NOTE:
CHANGES TO SHEETS 1, 3, 3A, 4, 6, 9C
NEW SHEETS 1, 10D

Designed: 9/28/16	MODIFICATION LEVEL		CIRCUIT MODIFICATIONS ARE NOT TO BE MADE WITHOUT AUTHORITY FROM THE OFFICE OF SIGNAL DESIGN	Date: 09/28/16	UNION PACIFIC RAILROAD
REVISE ROAD ANGLE AND LOOPS AT LINCOLN STREET M.P. 150.07	G. A. LAST LEVEL CHECKED	DU		Des: NST	LAWNDALE, ILLINOIS LINCOLN STREET SPRINGFIELD SUBDIVISION
	LAST LEVEL MOD THIS TYPICAL	DU		Chk: NBT	
	LAST LEVEL BY DESIGNER	DU		AFE: 22821	Office of AVP Engineering - Signal Omaha, Nebraska
Rec#: WO#: 22821	CHANGED FROM TYPICAL?	Y			
IS: NBT NST/JVJ	REV 01.24.11 4K 2TKEGMS.1

Sh.:	1
DOT	290978H
MP:	150.07
ID:	CSL15007.1X

Sh.:	4
DOT	290978H
MP:	150.07
ID:	CSL15007.4X

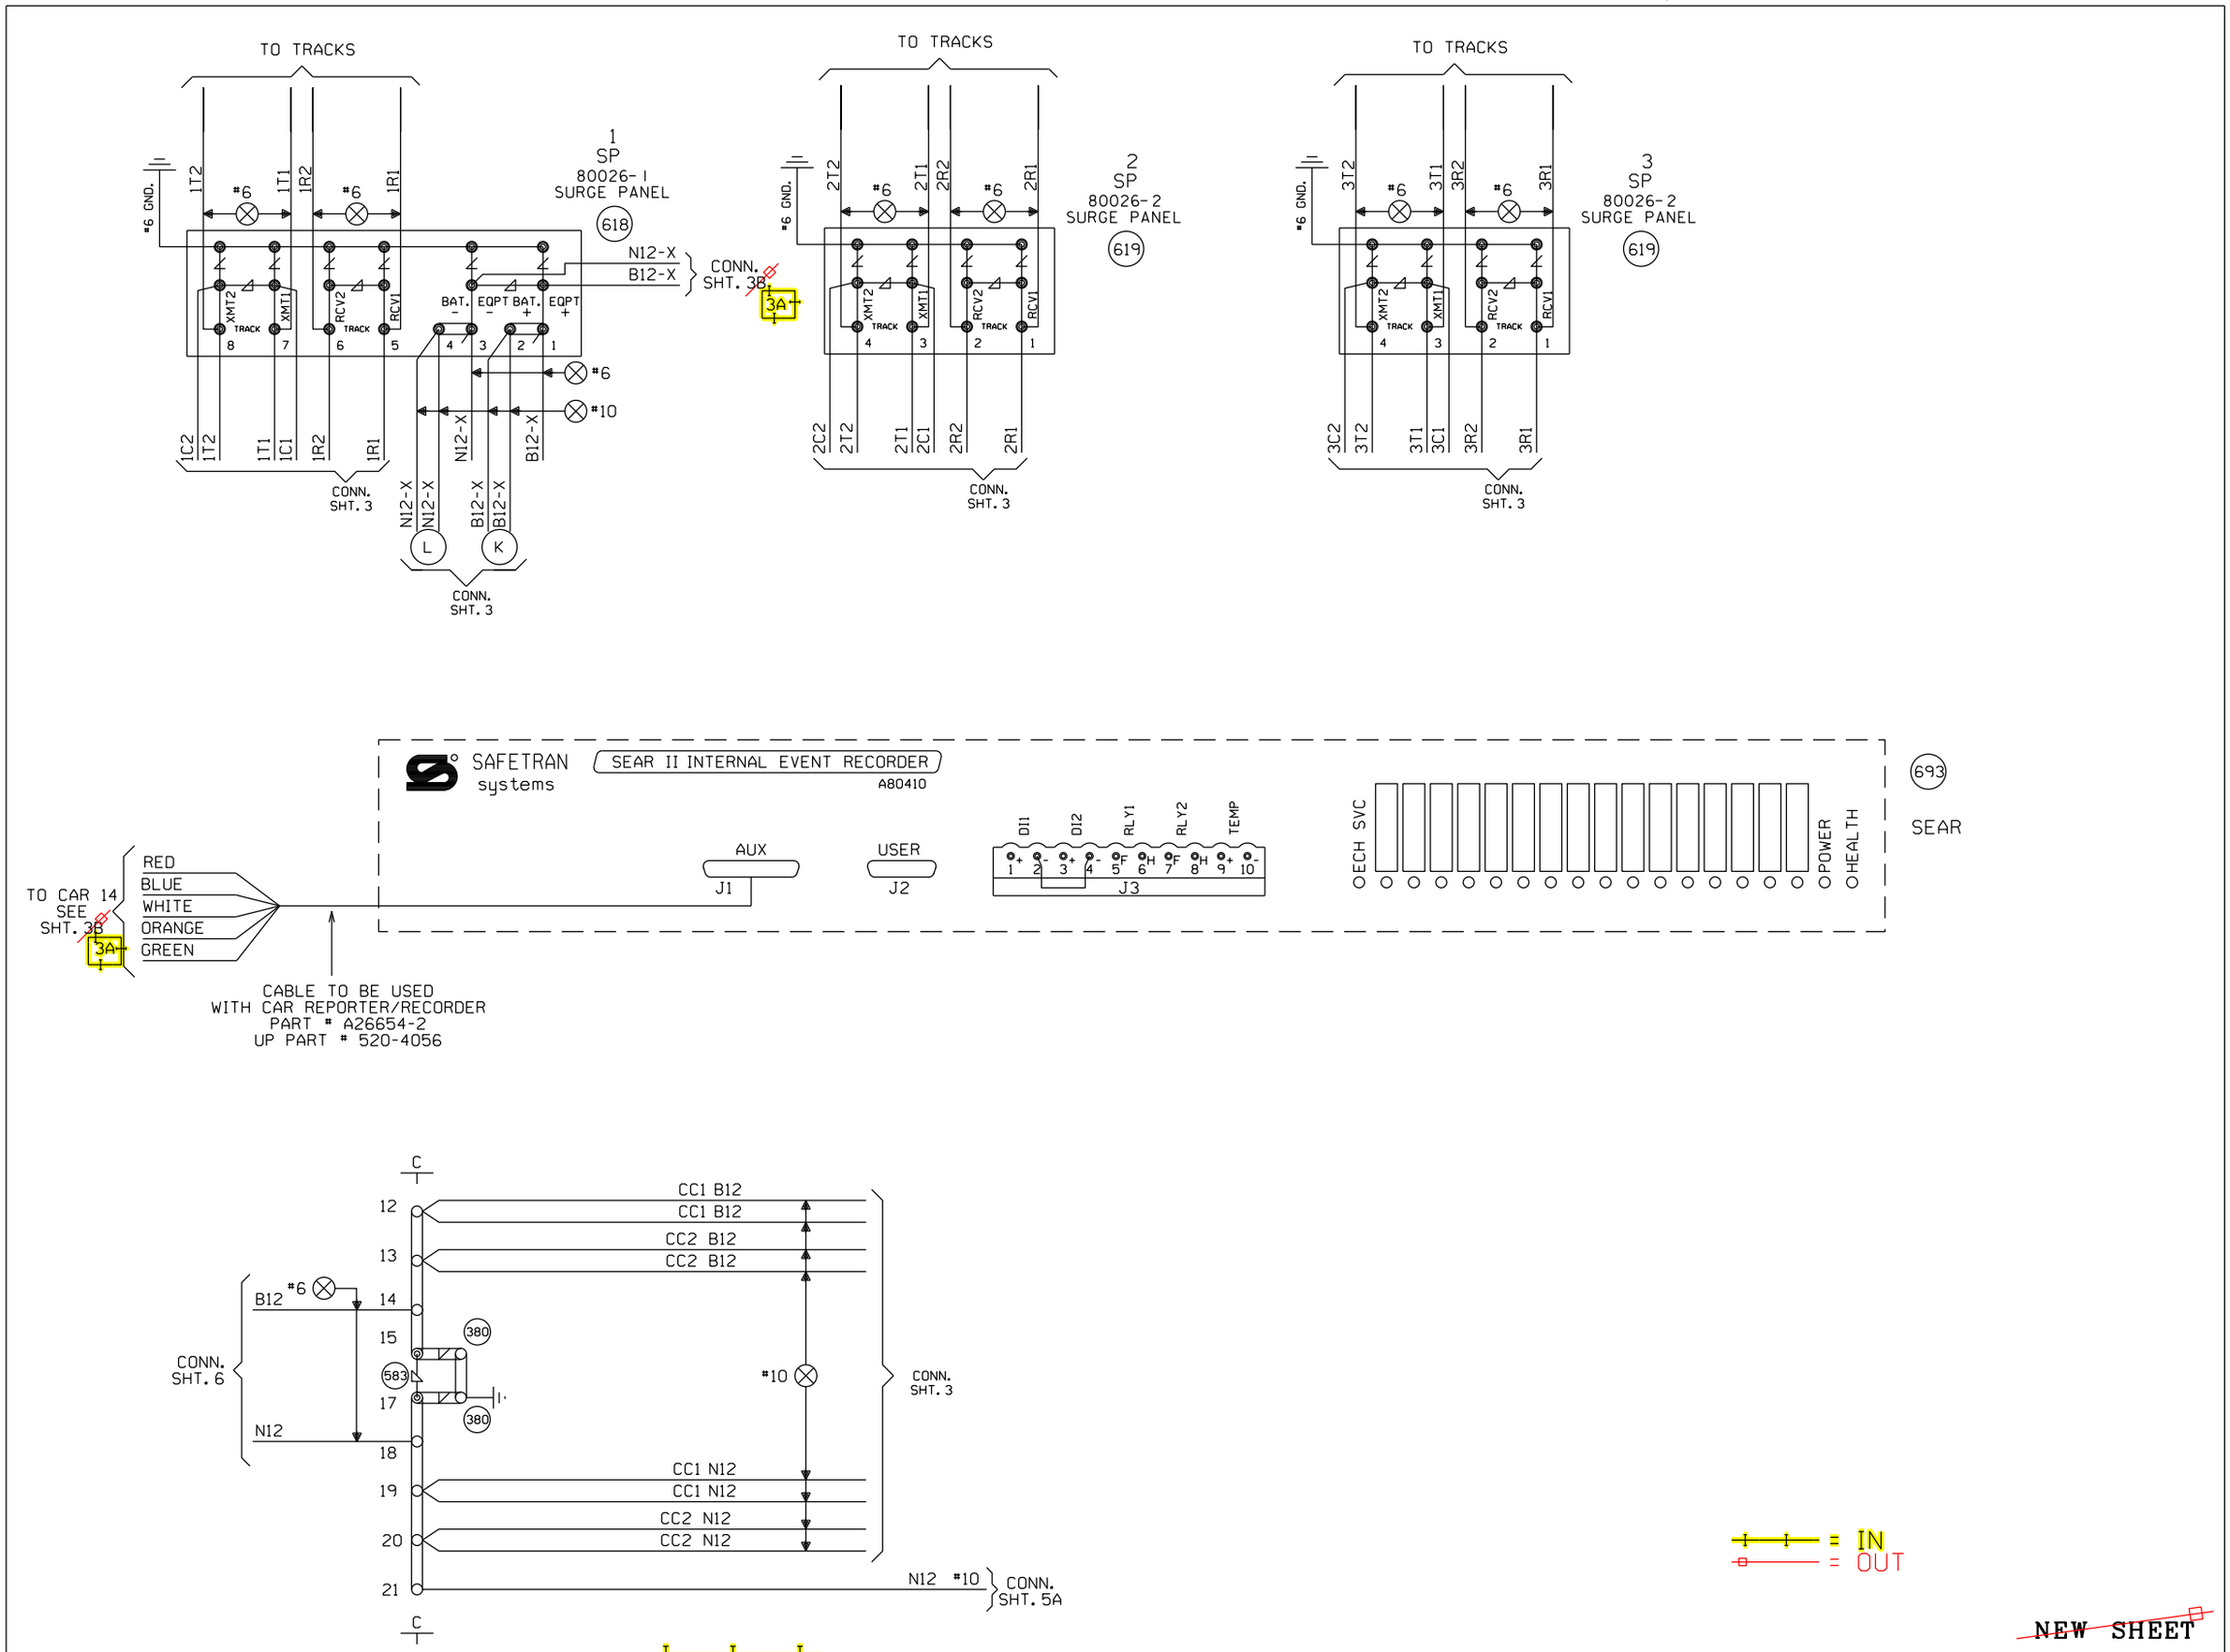
Designed: 9/28/16
REVISE ROAD ANGLE AND LOOPS AT LINCOLN STREET M.P. 150.07
Rec#: WO#: 22821
IS: /NBT /NST/JVJ

DATE 4-1-02
SHEET 6
DWG 150.15
RTE-CSL

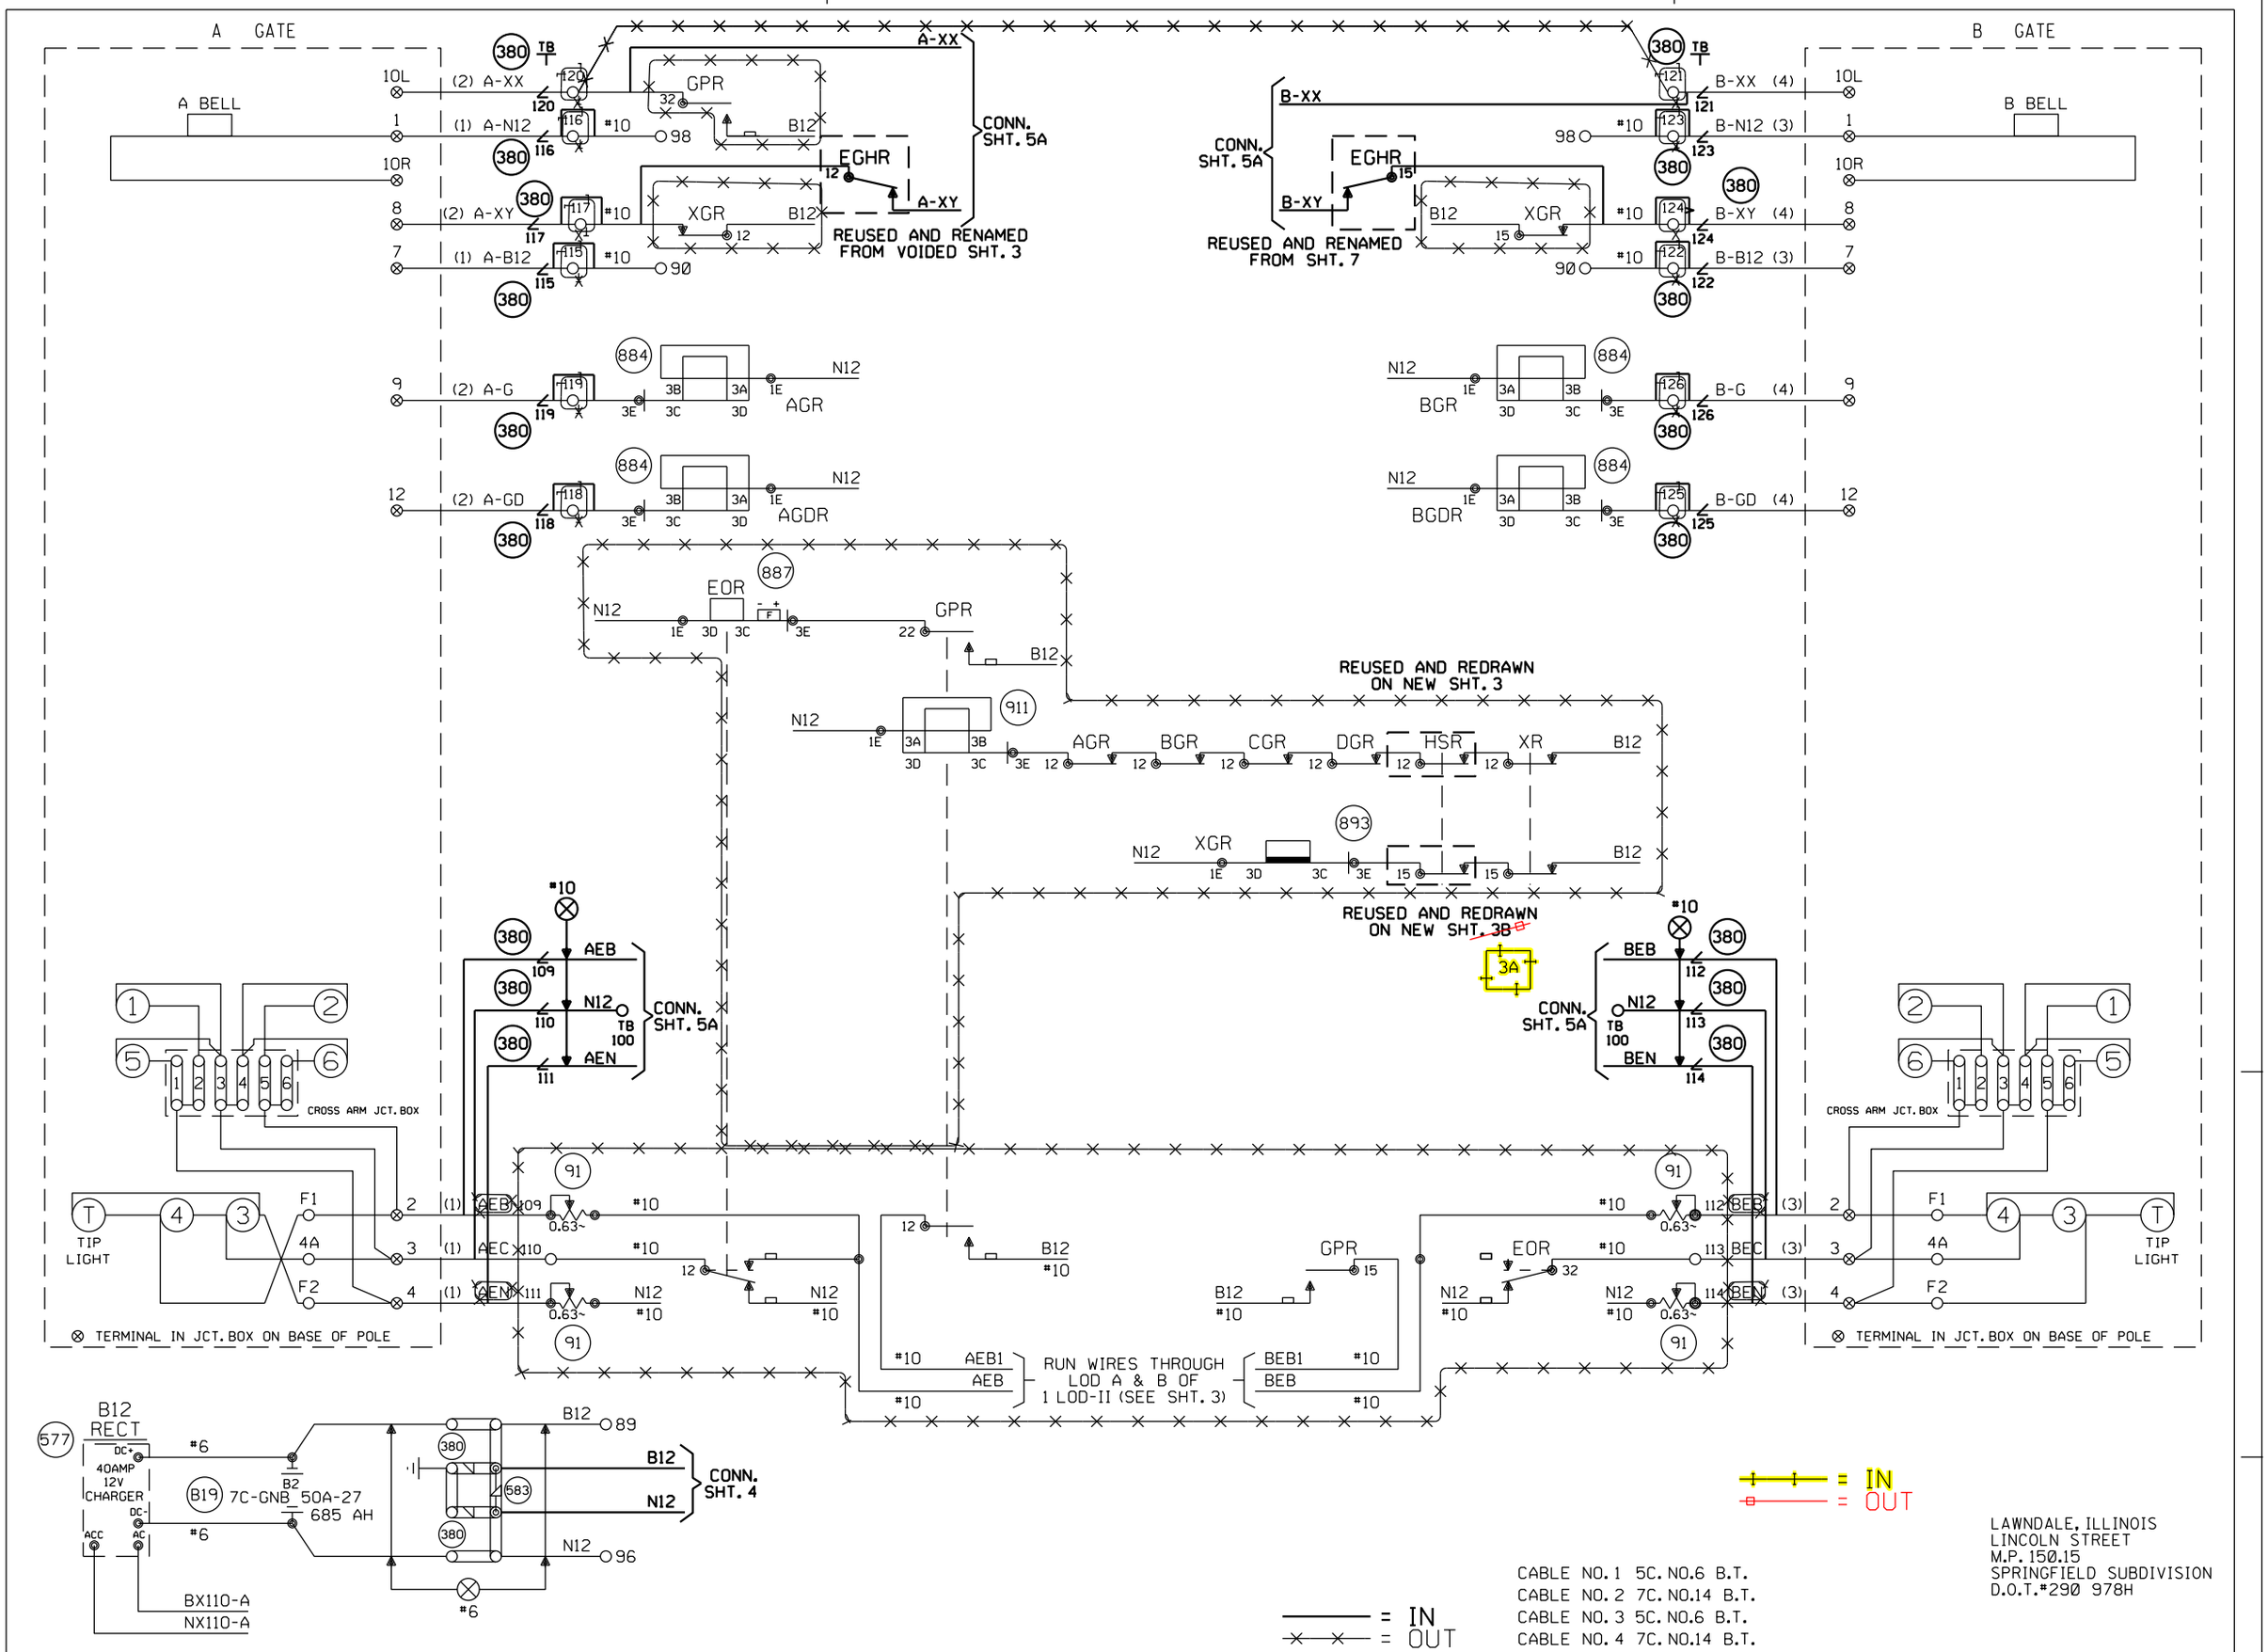
Designed: 4/28/16
REVISE ROAD ANGLE AND LOOPS AT LINCOLN STREET M.P. 150.07
Rec#: WO#: 22821
IS: NST/VJ
